COMMUNITY DEVELOPMENT DEPARTMENT REPORT

HEARING DATE: 8/7/2025
TO: Planning & Zoning Commission
FROM: Nick Napoli, Associate Planner
208-884-5533
nnapoli@meridiancity.org

SUBJECT: H-2025-0016
Farrington Heights Subdivision RZ, PP,
MDA

D. Landscape Plan (date: 5/11/2025)

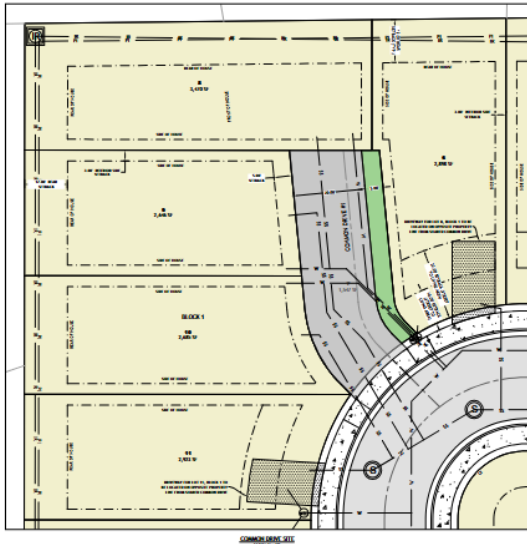
The applicant has provided a twenty-five (25) foot wide landscape buffer along E. Pine Avenue and is required to comply with the dimensional standards for the R-15 district. With the submittal of the final plat, the applicant shall provide vegetation coverage calculations.

- b. Provide details on the ground coverage material that will be used along Pine Avenue.
4. The proposed plat and subsequent development are required to comply with the dimensional standards listed in UDC Table 11-2A-5 and 11-2A-7 for the R-4 and R-15 zoning districts.

Farrington Heights
Common Area #1
Exhibit

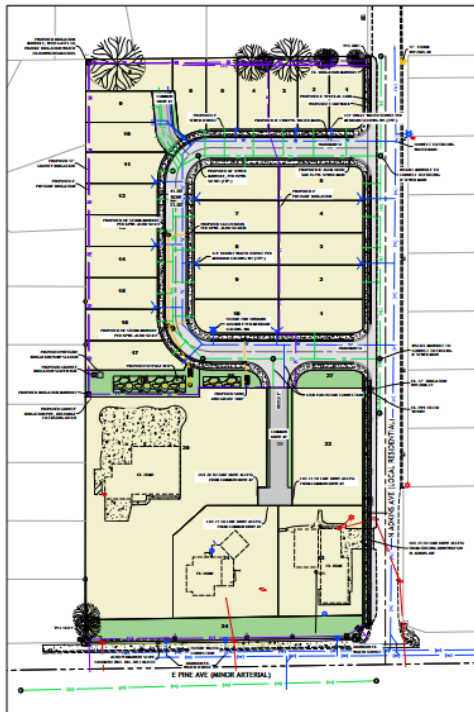
12. Submit an updated common drive exhibit for the southern common drive showing the driveways and the setbacks for the existing homes that will remain on Lots 20, 21, and 23, Block 1.
